SUBJECT: ISSUANCE OF AMENDMENT NO. 59 TO FACILITY OPERATING LICENSE
NO. NPF-29 - GRAND GULF NUCLEAR STATION, UNIT 1, REGARDING
USE OF AN ALTERNATE DECAY HEAT REMOVAL SYSTEM (TAC NO. 69403)

SAFETY EVALUATION BY THE OFFICE OF NUCLEAR REACTOR REGULATION

SUPPORTING AMENDMENT NO. 59 TO FACILITY OPERATING LICENSE NO. NPF-29

GRAND GULF NUCLEAR STATION, UNIT 1

FIGURE 1: ALTERNATE DECAY HEAT REMOVAL SYSTEM

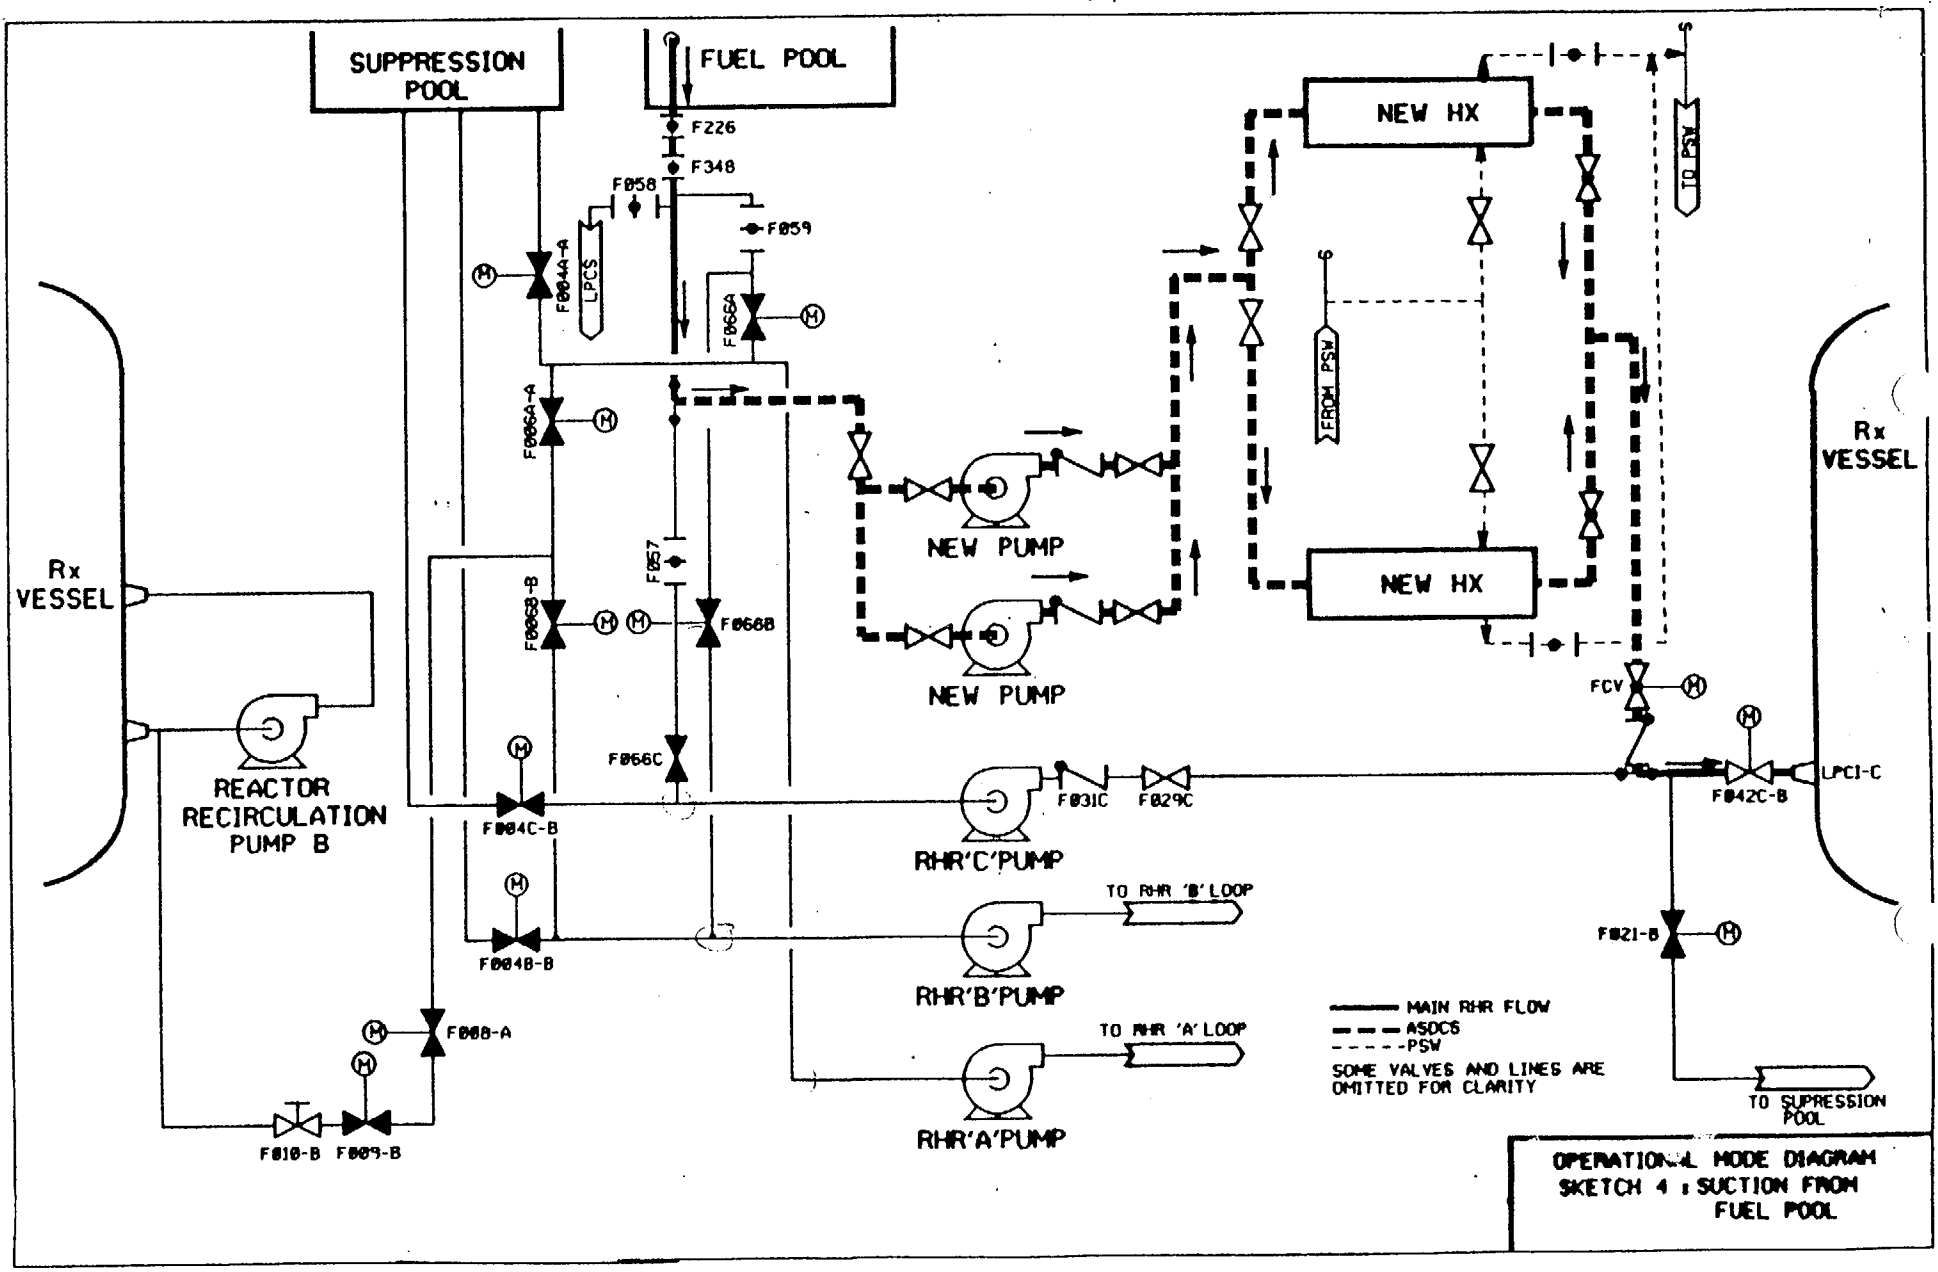
A flow diagram of the ADHRS is attached as Figure 1. The ADHRS consists of existing and new components. The existing components include the common RHR shutdown cooling suction line and fuel pool cooling and cleanup (FPCCU) piping. The new components include two ADHRS pumps, two heat exchangers, associated piping, valves, instrumentation and controls. A manually operated valve is added to isolate ADHRS from the FPCCU. In order to minimize the piping lengths, the new ADHRS equipment is located in RHR 'C' pump room. Functional control is provided from the main control room. The PSW system provides coolant to the ADHRS heat exchangers for heat removal. A radiation monitor with an alarm indicator in the control room is added to the PSW cooling water discharge header to detect intersystem leakage from a heat exchanger tube leakage or failure. Motor operators are added to valves E12F066A and B to allow the valves to be remote manually operated from the control room. The functional purpose of the ADHRS is important to safety, but is not safety related, since the ADHRS does not automatically mitigate the consequences resulting from accidents. However, safety-related components are used in various portions of the ADHRS to ensure that current safety-related requirements of the ECCS and RHR system are not compromised by the installation or use of the ADHRS.

In OC 4 and 5, more interactions are potentially possible between the ADHRS and the safety-related RHR shutdown cooling loops and ECCS subsystems. As shown in Figure 1, the ADHRS suction is connected to the fuel pool cooling and cleanup line which is joined to the RHR A, B and C loop suction piping. This results in the need for additional procedural controls and constraints to assure continued shutdown cooling and ECCS injection when the ADHRS is being operated.

FIGURE 2

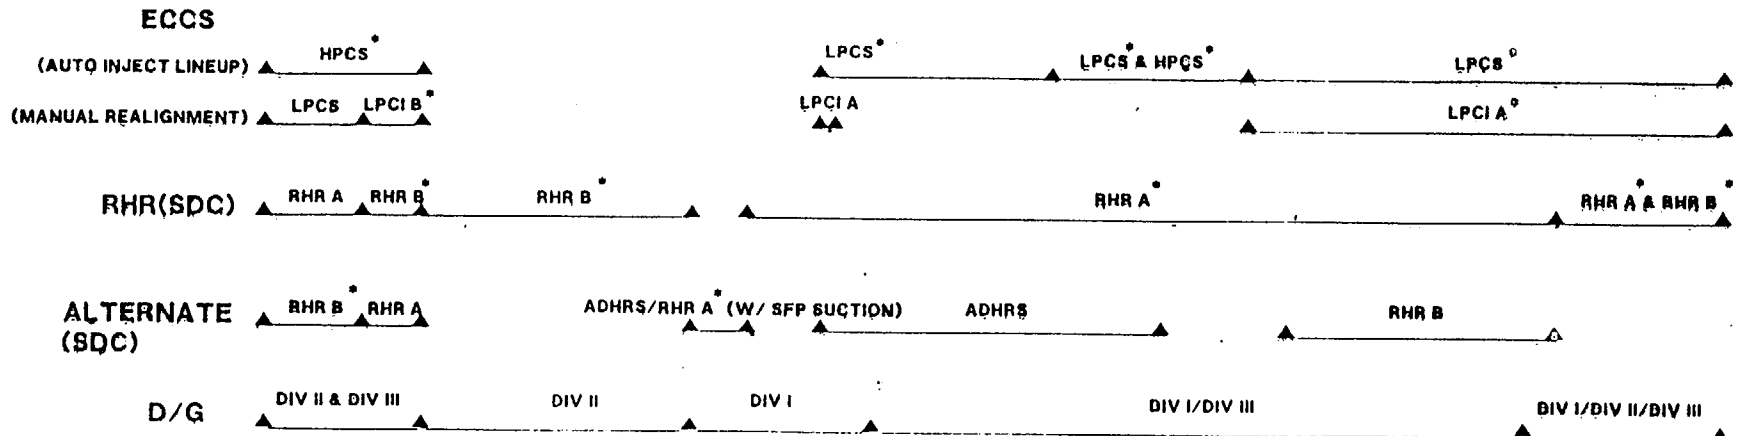
The ADHRS could be used during cold shutdown (OC 4) and refueling (OC 5) for shutdown cooling to supplement the residual heat removal function of the RHR system. The proposed use of the ADHRS together with the use of the RHR loops for shutdown cooling (SDC), the use of ECCS systems for water injection and associated diesel generators (DG) are shown for RFO3 in Figure 2 (attached). Plant operational conditions (labeled MODE in Figure 2) are shown in Item I. TS LCO requirements for shutdown cooling loops (TS 3.4.9.2, TS 3.9.11.1, TS 3.9.11.2), ECCS subsystems (TS 3.5.2), and diesel generators (TS 3.8.1.2) are indicated in Item II of Figure 2. The scheduled ECCS subsystems, RHR loops, ADHRS and DGs are indicated in Item III of Figure 2.

Thus, for example, in the first two days of the outage (See Figure 2) while in OC 4 with the reactor pressure vessel head on, HPCS can be powered by DIV III DG and the alternate shutdown cooling loop RHR B can be powered by DIV II DG (indicated by an asterisk in Figure 2). The other two loops, LPCS and RHR A can only be powered by offsite power during this portion of the outage because the DIV I DG is undergoing maintenance. The ADHRS is designed for operation on offsite power only. In Item III of Figure 2, the RHR (SDC) line shows which RHR loops are operable. The Alternate (SDC) line shows the RHR loops that are not operable, but will be used as the "alternate method capable of decay heat removal" allowed in Action a of TS 3.4.9.2, TS 3.9.11.1 and TS 3.9.11.2, when an RHR train is not operable.
